Objection to Application 2016/7113/P

The site, 128 Camden Road, is located within Camden Broadway Conservation Area. The map below shows the boundaries of the conservation area, and highlights the site as a 'positive building'.

EXISTING FRONT ELEVATION

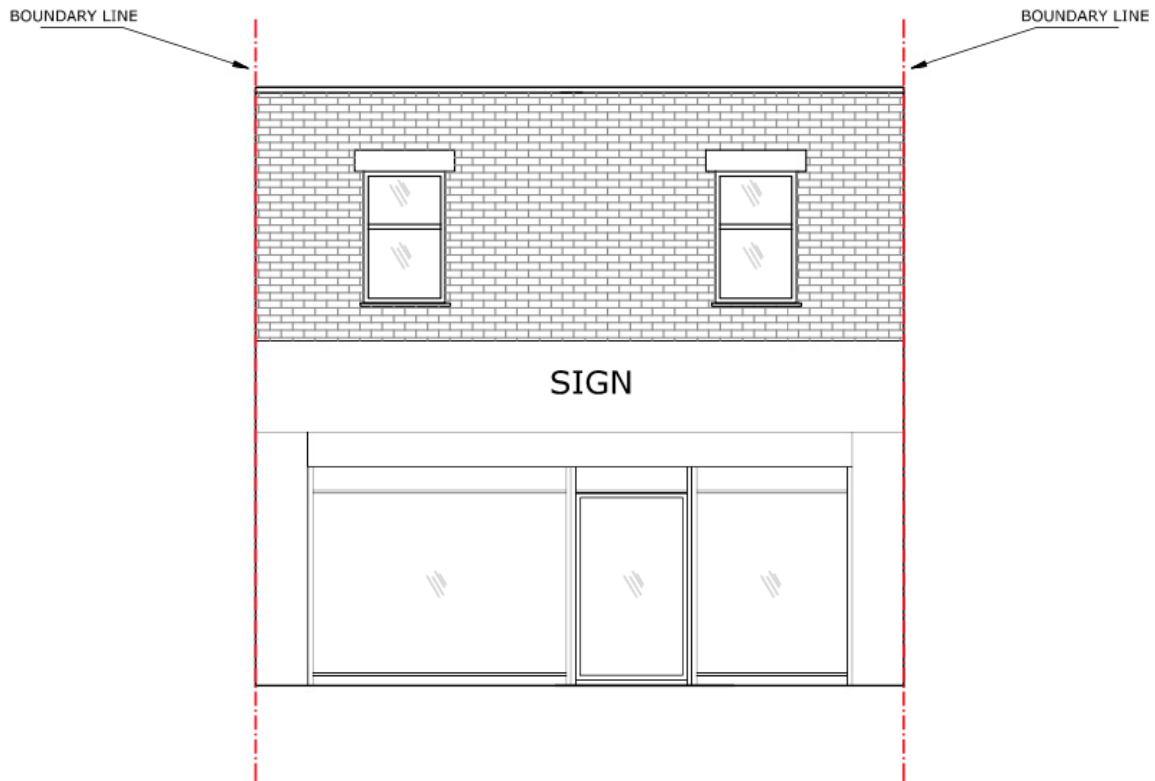
The front elevation shown on drawing P 101 depicts several incorrect details. The window detailing, proportions as well as the vertical bricks above the window have been drawn incorrectly, as shown in the figures below. It also misses out items such as the air conditioning unit to the left, the projecting advertising sign to the right and the historic timber frames above the windows.

As the committee has not had access to the building itself or its rear, it has therefore noted that the accuracy of the plans and rear elevation may need to be questioned.
